John K. Wood  
Vice President, Nuclear440-280-5224  
Fax: 440-280-8029January 15, 2001  
PY-CEI/NRR-2538LUnited States Nuclear Regulatory Commission  
Document Control Desk  
Washington, D.C. 20555Perry Nuclear Power Plant  
Docket No. 50-440  
Supplement to a License Amendment Request Pursuant to 10CFR50.90:  
Activation of Thermal-Hydraulic Stability Monitoring Instrumentation

The changes being proposed by this supplement are in Technical Specification 3.3.1.3, "Oscillation Power Range Monitor (OPRM) Instrumentation":

#### 3.3.1.3 Oscillation Power Range Monitor (OPRM) Instrumentation

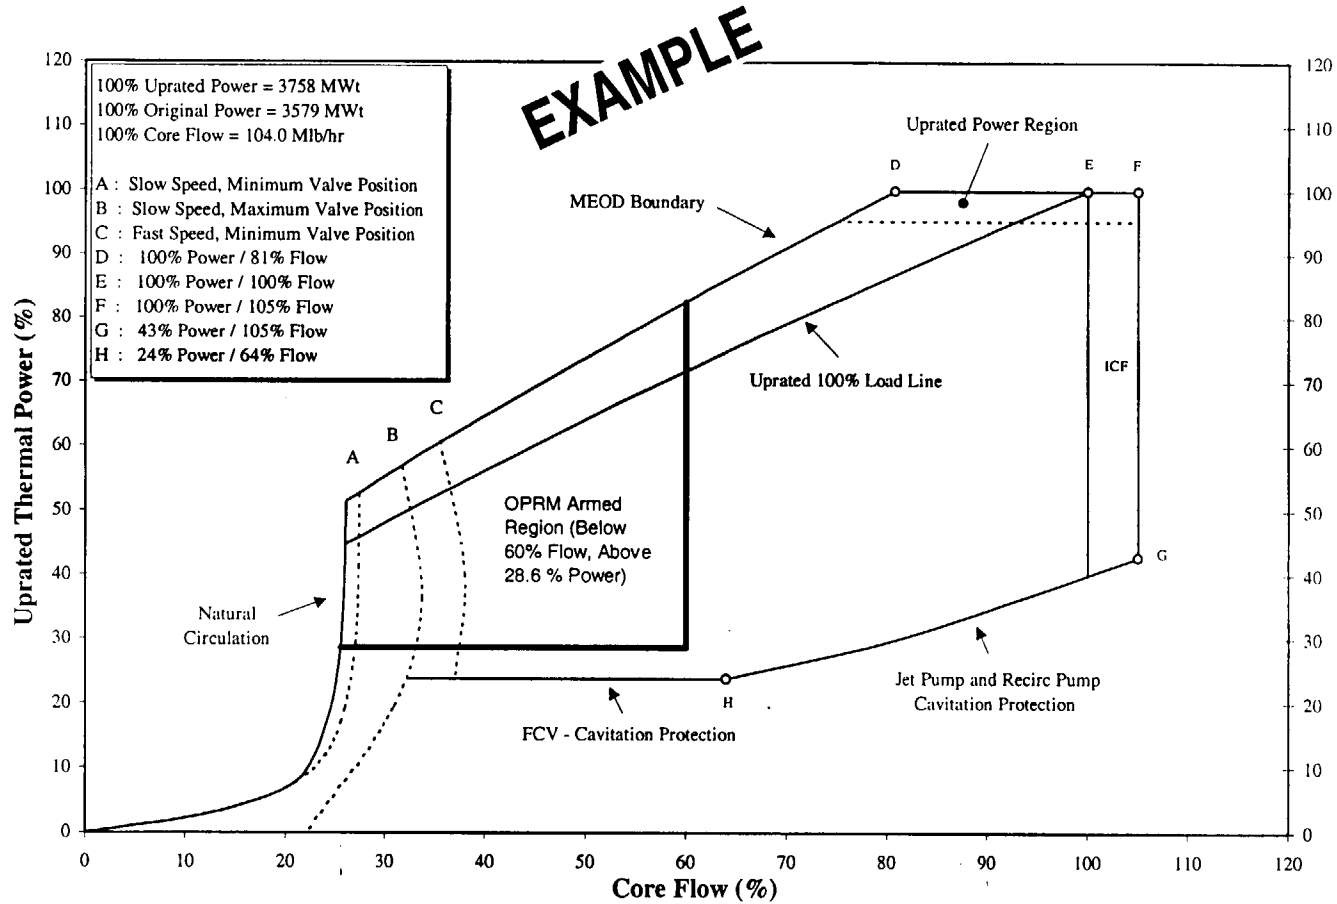
1. The Applicability, and Required Action C.1, are revised to reference 23.8% Rated Thermal Power (RTP) rather than 25% RTP.
2. The "power level" component of the Enabled (Armed) Region in Surveillance Requirement (SR) 3.3.1.3.5 is specified as 28.6% RTP rather than 30% RTP.

APPLICABILITY: THERMAL POWER  $\geq$  23.8% RTP

CONDITION	REQUIRED ACTION	COMPLETION TIME
A. One or more required channels inoperable.	A.1 Place channel in trip. <u>OR</u>	30 days
	A.2 Place associated RPS trip system in trip. <u>OR</u>	30 days
	A.3 Initiate alternate method to detect and suppress thermal hydraulic instability oscillations.	30 days
B. OPRM trip capability not maintained.	B.1 Initiate alternate method to detect and suppress thermal hydraulic instability oscillations.	12 hours
C. Required Action and associated Completion Time not met.	C.1 Reduce THERMAL POWER to < 23.8% RTP.	4 hours

# Perry 105% Power Uprate Power/Flow Map (OPRM Armed Region)

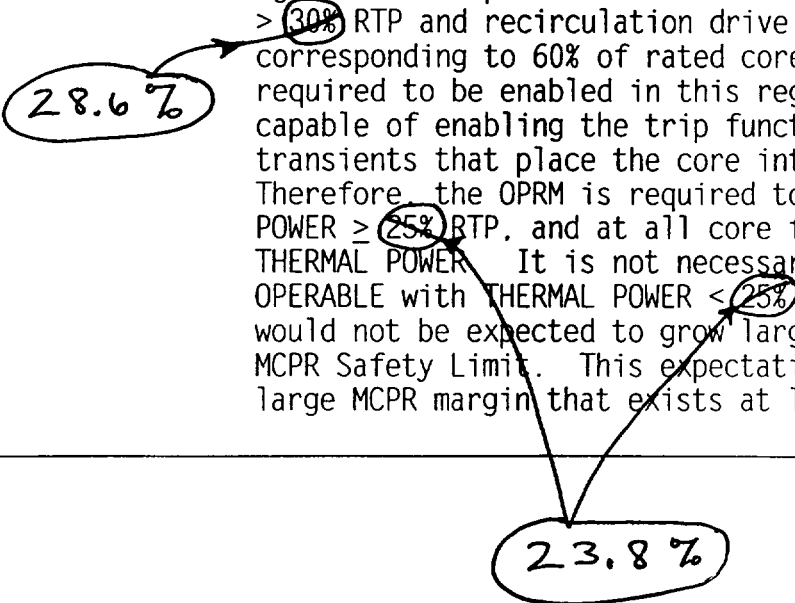
Attachment 4 provides an example Power/Flow Map showing this post-uprate OPRM Armed Region.
